**REPORT FROM KATESTONE ENVIRONMENTAL  
TO ALCOA WORLD ALUMINA AUSTRALIA**

**DESKTOP REVIEW OF THE CSIRO PHASE 1, 2 AND 3A FOR  
ASSESSMENT OF THE ALCOA WAGERUP REFINERY  
EXPANSION**

**January 2005**

**Figure 1: Source identification using non-parametric regression for Boundary Road and Upper Dam NO<sub>x</sub> data**

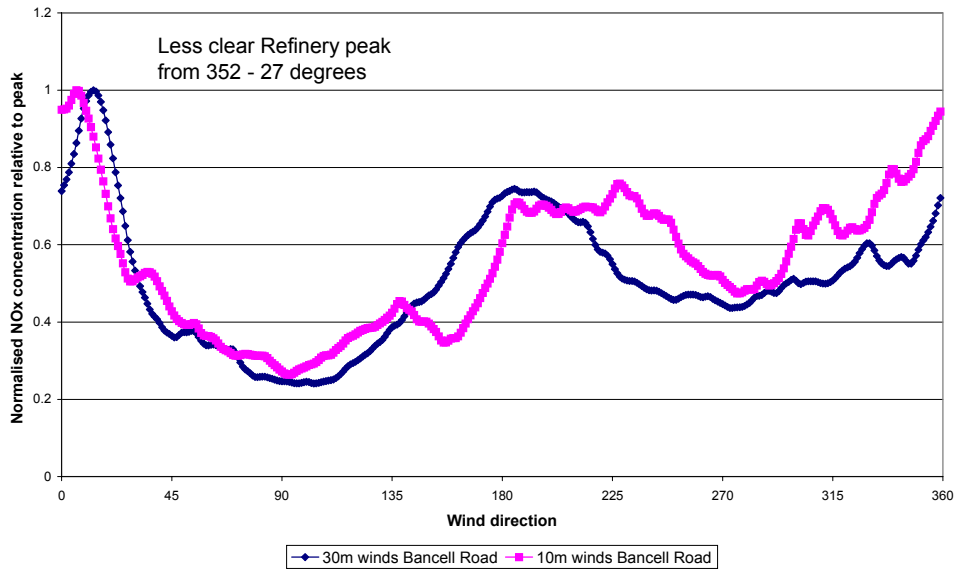
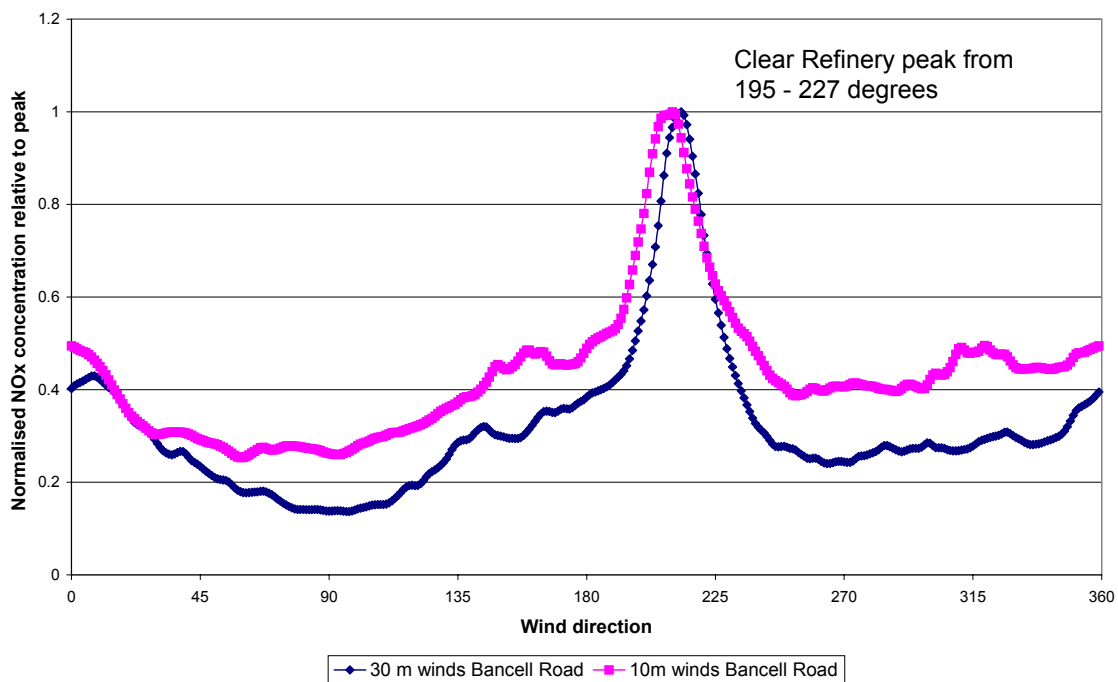
Figure 1 shows that there is a clear refinery signal in the Upper Dam site data but a variety of possible sources for the other site. Figure 2 suggests that there are many instances of concurrent events at both sites, suggesting a regional, rather than refinery source.

These results suggest that a very careful culling of events is required in any model validation study for the area. The Upper Dam site is obviously the preferred choice for the use of nitrogen oxide information.

**Figure 3: NO<sub>2</sub>/NO<sub>x</sub> ratio versus NO<sub>x</sub> concentrations for winds from refinery sector for (a) Boundary Road and (b) Upper Dam**

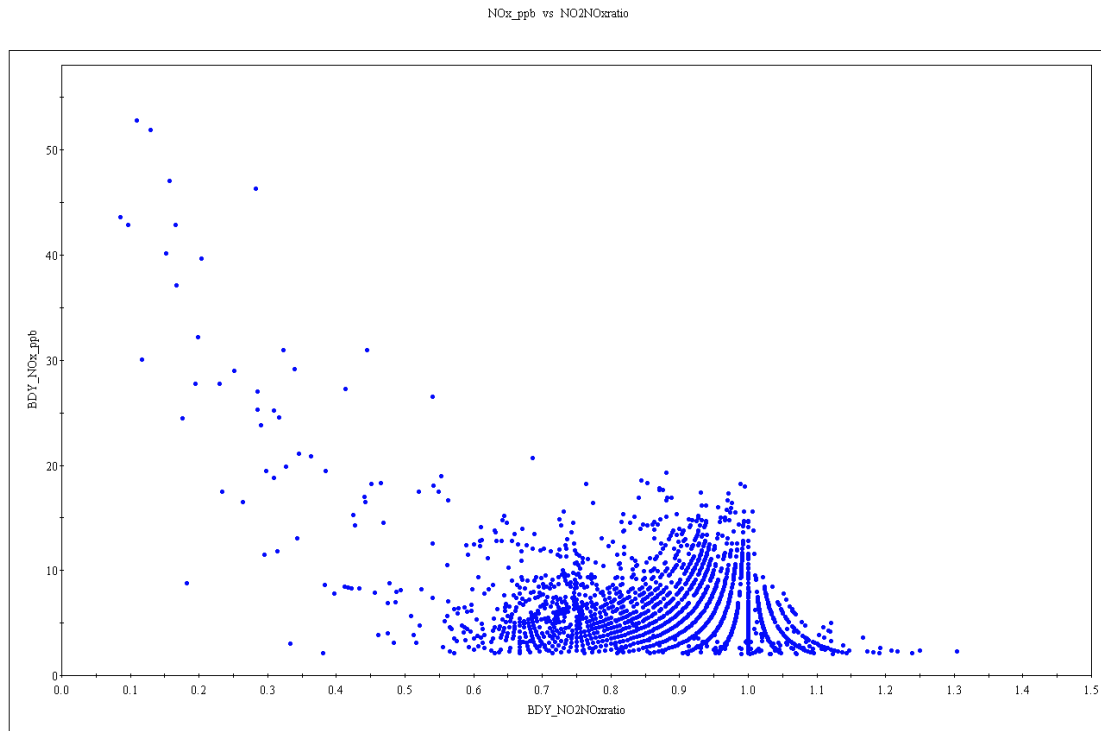
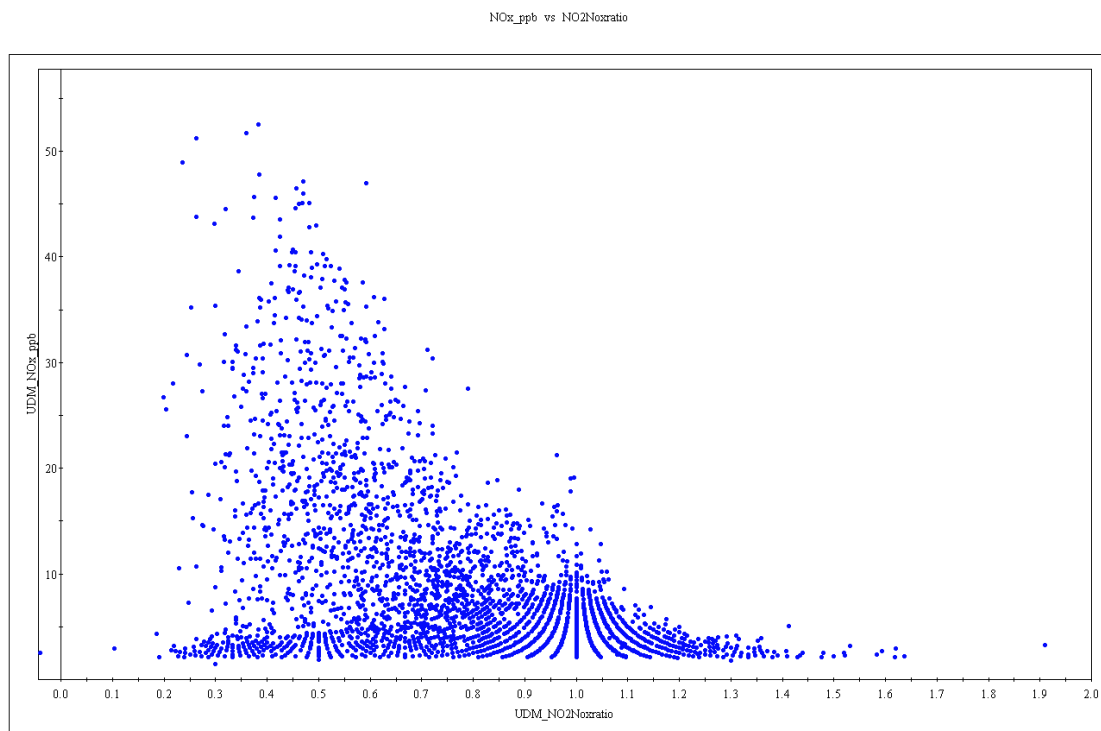
The ratios of nitrogen dioxide to total nitrogen oxides for the refinery sources are expected to be around 0.1 at stack exit and 0.2 - 0.3 within the first 3 kilometres or so from the relevant sources. Figure 3 then shows that there is an obvious refinery source for the Upper Dam data but other sources are important for some of the moderate-size events.

**Figure 4: Comparison of wind roses for concurrent data recorded at (a) RDA and (b) Bancell Road 30m**

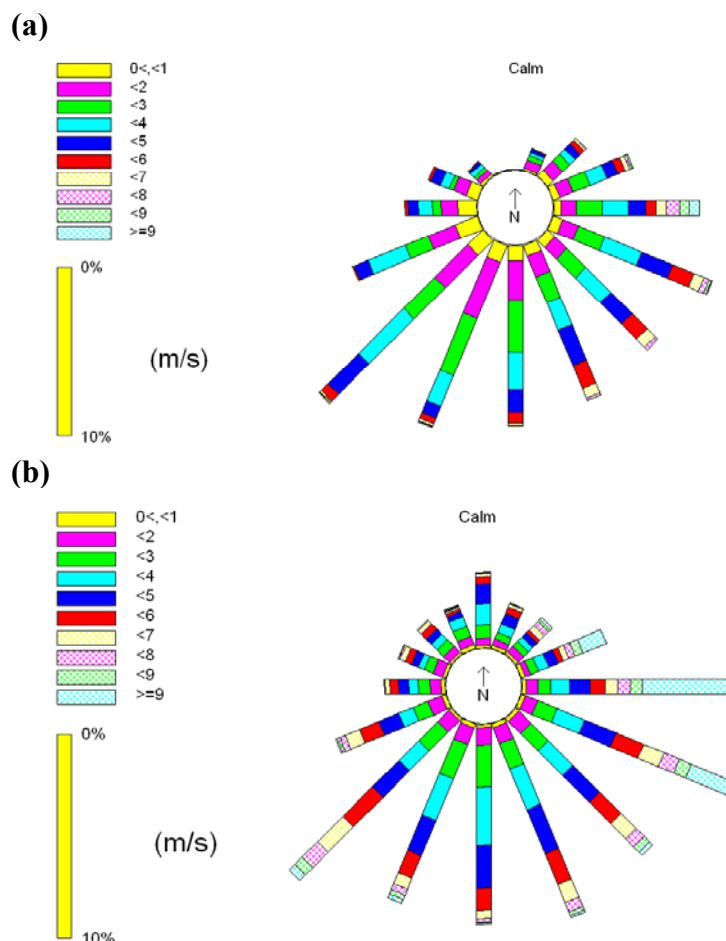
Phase 3a modelling needs more justification than currently presented. If it is not appropriate to use data assimilation with a radius of influence that covers areas of different meteorological conditions, why was it tested in the Phase 2 report? From inspection of the wind roses in Figure 4 for the RDA and Bancell Road sites the overall distribution of winds is comparable at both sites. Again we recommend that the final configuration used in the modelling for the HRA needs to be the configuration of the model tested and shown to be the most appropriate in the Phase 2 report and the use of data assimilation using the 30 m wind data from Bancell Road is recommended.

The CSIRO report also evaluates the performance against information from the RDA site to the west of the refinery. The meteorological monitoring data recorded at RDA site may be invalid or contains errors as there are few winds from the north-north west or northerly sectors. The figures below show the wind roses for RDA and 30 m winds at Bancell road site for the period of concurrent data (December 2003 to April 2004).

**Figure 5: Analysis of Upper Dam for peak 6 minute verses 1 hour average  $\text{NO}_x$  data for winds from Refinery sector ( $195-227^\circ$ )**

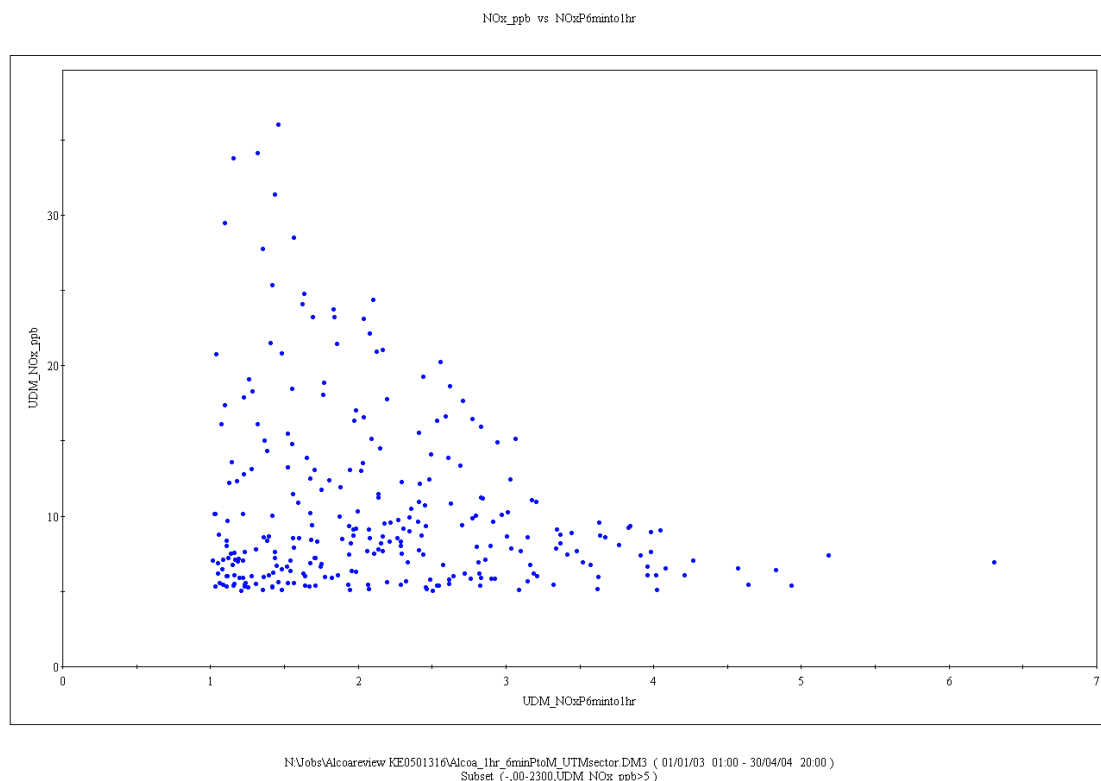
Figure 3 below presents a scatter plot of the measurements from Upper Dam site when winds were from the Refinery for hourly averages versus peak 6-minute concentrations recorded for each hour. It can be seen that for the highest hourly average concentrations recorded ( $>30 \mu\text{g}/\text{m}^3$ ) at the Upper Dam site the peak 6-minute average is about 1-1.5. For lower concentrations the spread in the ratio is much greater with ratios up to 2.5 for concentrations of  $20 \mu\text{g}/\text{m}^3$ . This shows that for differently hourly average concentrations the peak concentrations within the hour can be the same (e.g.  $30 \mu\text{g}/\text{m}^3 \times 1.5$  or  $18 \mu\text{g}/\text{m}^3 \times 2.5$  both equal a peak 6-minute concentration of  $45 \mu\text{g}/\text{m}^3$ ).

The peak to mean ratios found from the measurements are much lower than expected based on experience elsewhere. It is not known if this relatively small power law exponent would translate for much shorter-term peaks, say 1 second, which are likely to drive the probability of complaints.

**Figure 6: Cumulative frequency distribution of measurements of NO<sub>x</sub> at Upper Dam for winds from the Refinery for hourly and 6 minute averages and for estimated 6 minute averages using exponents of 0.12 and 0.23.**

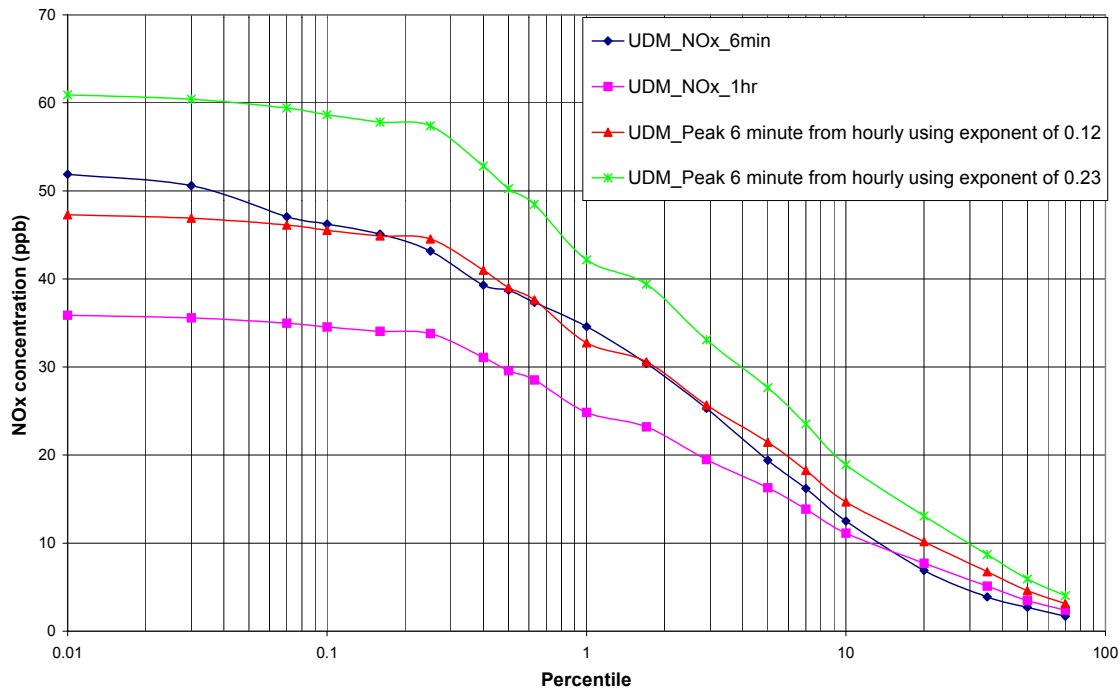
Figure 4 presents the frequency distribution of measurements from the Upper Dam site for the times winds were blowing from the Refinery. From the hourly average frequency distribution the peak 6-minute concentrations have been estimated using the method described in the CSIRO report with exponents in the range 0.12 to 0.23. The distribution of 6-minute concentrations indicates that the exponents used by CSIRO are within the range of the measurements (0.23 is actually slightly high).
